Dockets Nos. 50-317 and 50-318 JUL 31 1980

The Commission has issued the enclosed Amendments Nos. 49 and 26 to Facility Operating Licenses Nos. DPR-53 and DPR-69 for the Calvert Cliffs Nuclear Power Plant, Units Nos. 1 and 2. These amendments consist of changes to the Appendix A and Appendix B Technical Specifications in response to your applications dated July 24, 1979 (Item 5 only) and as supplemented by your letter of June 24, 1980.

SUBJECT: CALVERT CLIFFS, UNITS 1 AND 2

Amendment No. 43  
License No. DPR-53

FIGURE 6.2-1 Management Organization Chart - Calvert Cliffs Nuclear Power Plant  
Baltimore Gas & Electric Company

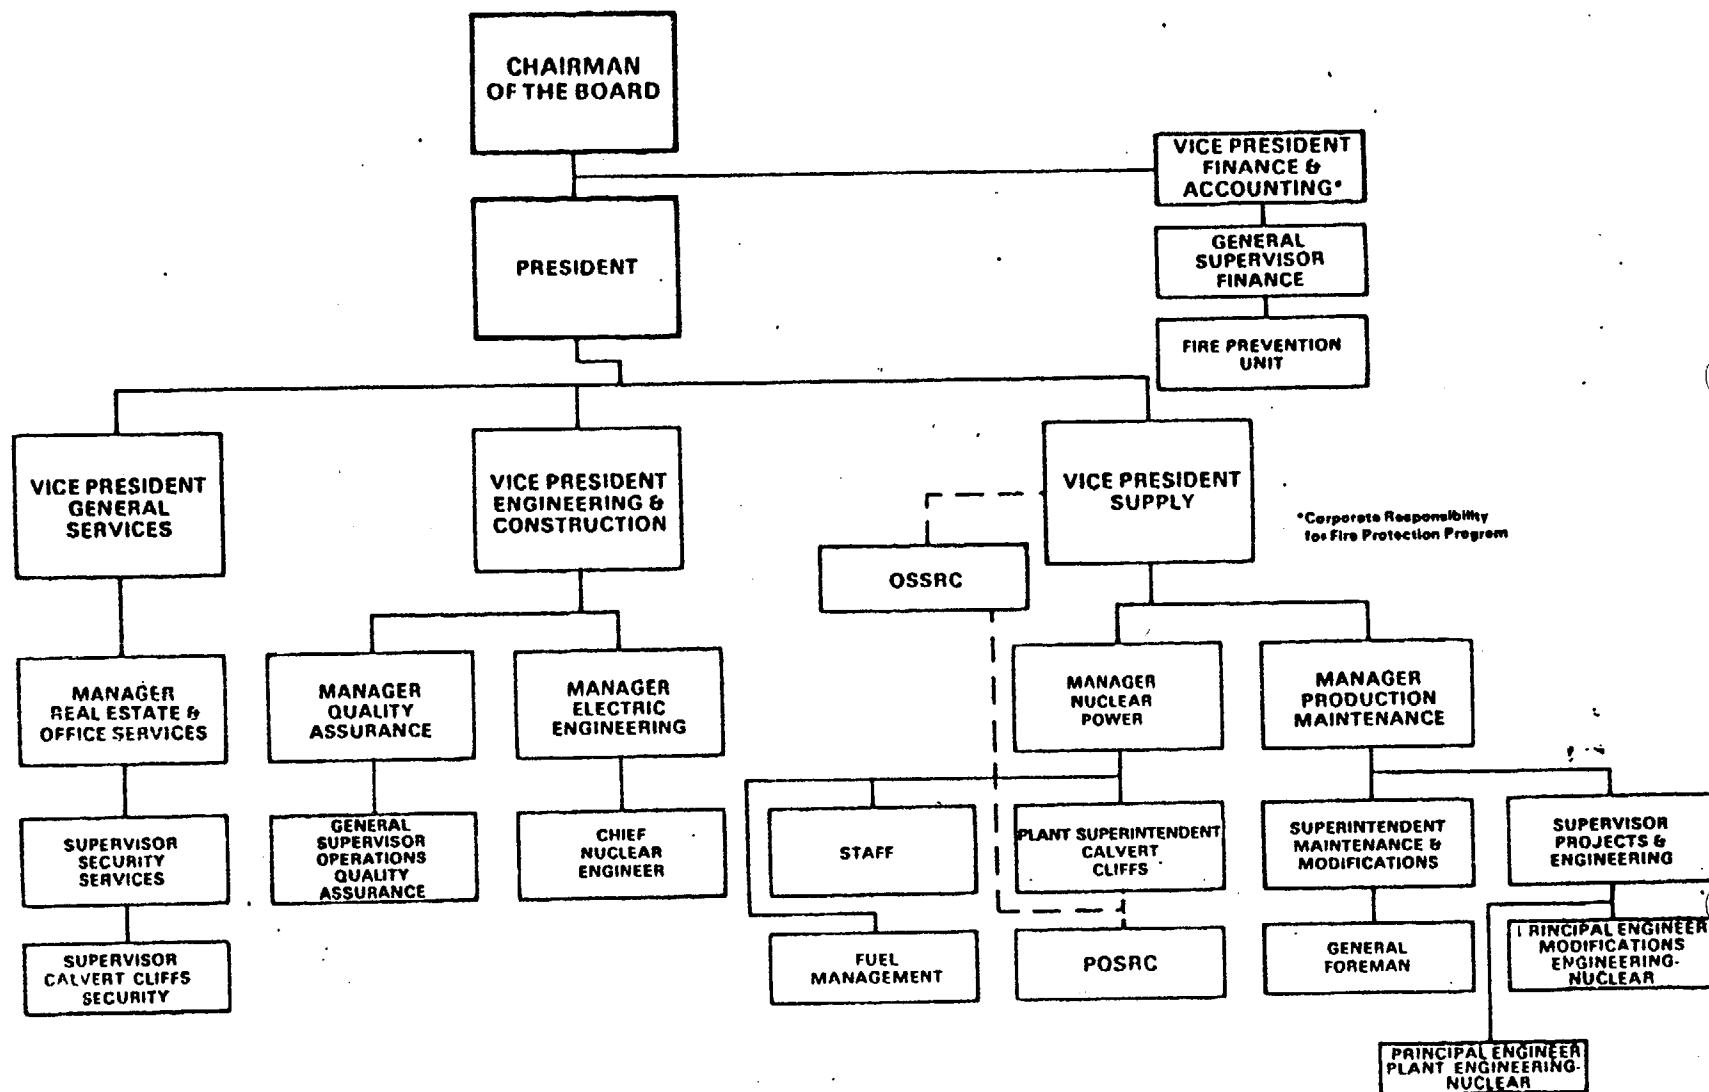
We find that the requested administrative changes to Figures 6.2-1 and 6.2-2 and the other sections related to this change are acceptable. The changes on the composition of the OSSRC committee are similar to the composition in the Standard Technical Specifications of other recently licensed plants and is therefore acceptable.

We find that the requested administrative changes to Figures 6.2-1 and 6.2-2 and the other sections related to this change are acceptable. The changes on the composition of the OSSRC committee are similar to the composition in the Standard Technical Specifications of other recently licensed plants and are therefore acceptable.

6.2.1 The offsite organization for facility management and technical support shall be as shown on Figure 6.2-1.
